# UNITED STATES PATENT AND TRADEMARK OFFICE

10/674,622

This is the first office action for application number 10/674,622, Bottle Retainer, filed on September 30, 2003.

Claims 1-4 and 7-10 are rejected under 35 U.S.C. 102(b) as being anticipated by U.S. Patent number 5,655,673 to Weterrings et al.

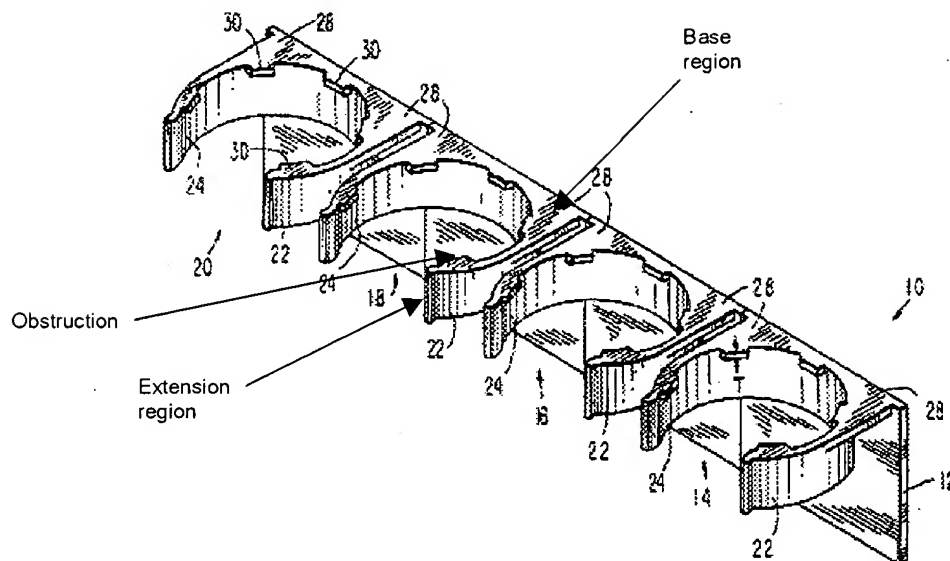
Weterrings et al. <sup>6</sup>73 discloses a retainer (above) comprising a base having an affixing portion (12) and a retaining portion (14,16,18,20, generally) forming at least one opening/receiving means (between 22,24), the affixing portion having a back side and a front side, wherein the back side is adapted for mounting the retainer to a surface, wherein the opening is inherently adapted to slidably receive a bottle therein, wherein the retaining portion further comprises at least three bifurcated arms/receiving means (22,24, above) wherein the arms form at least two openings (between 22,24 above) that can inherently slidably pass bottles therethrough, wherein the bifurcated arms have a base region (above) and an extension region (above), wherein the bifurcated have at least one obstruction (above) positioned on the extension region in coordination with the openings thereby inherently restricting accidental bottle disengagement, wherein the back side of the affixing portion further includes an adhesive layer (32) that is adapted

to mount the retainer to a surface, wherein the at least two openings are equivalent in size.

Claims 1, 2 and 5 are rejected under 35 U.S.C. 102(b) as being anticipated by U.S. Patent number 2,921,690 to Smith et al.

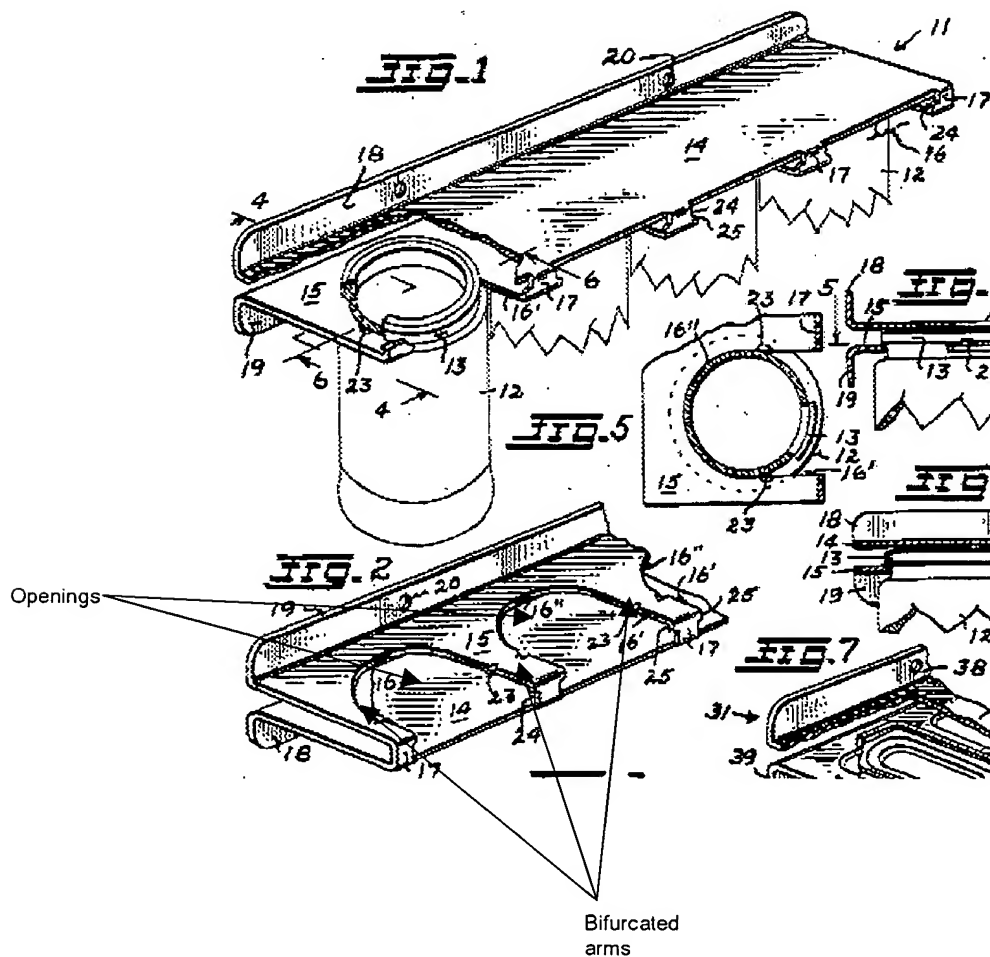
Smith et al. '690 discloses a retainer (above) comprising a base having an affixing portion (19) and a retaining portion (15, generally), the affixing portion having a

back side and a front side, the back side for mounting the retainer to a surface (column 2, lines 26-30), the retaining portion forming at least one opening (above) that is inherently adapted to slidably receive a bottle therein, wherein the retaining portion further comprises at least three bifurcated arms (above) that form at least two openings inherently for slidably passing bottles therethrough, wherein the affixing layer/portion is further inherently adapted to allow at least one nail to pass therethrough (through portion 20) so as to mount the retainer to a surface.

Claims 1, 2 and 6 are rejected under 35 U.S.C. 102(b) as being anticipated by U.S. Patent number Des. 262,504 to Flynn.

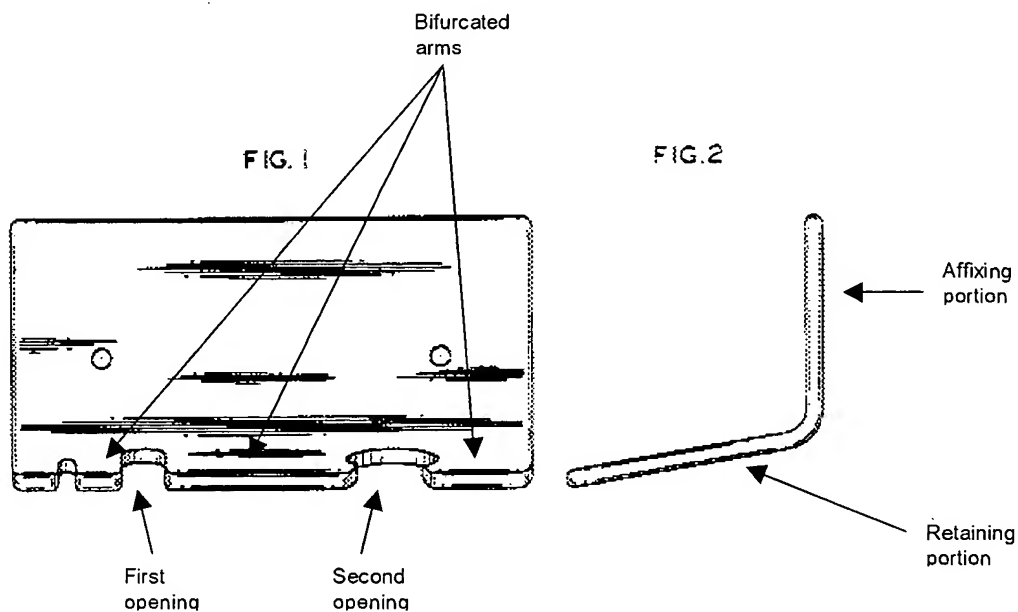
Flynn '504 discloses a retainer (above) comprising a base having an affixing portion (above) and a retaining portion (above), the affixing portion having a back side and a front side, the back side can inherently mounting the retainer to a surface, the retaining portion forming at least one opening (above) that is inherently adapted to

slidably receive a bottle therein, wherein the retaining portion further comprises at least three bifurcated arms (above) that form at least two openings inherently for slidably passing bottles therethrough, wherein the first opening is smaller than the second opening.
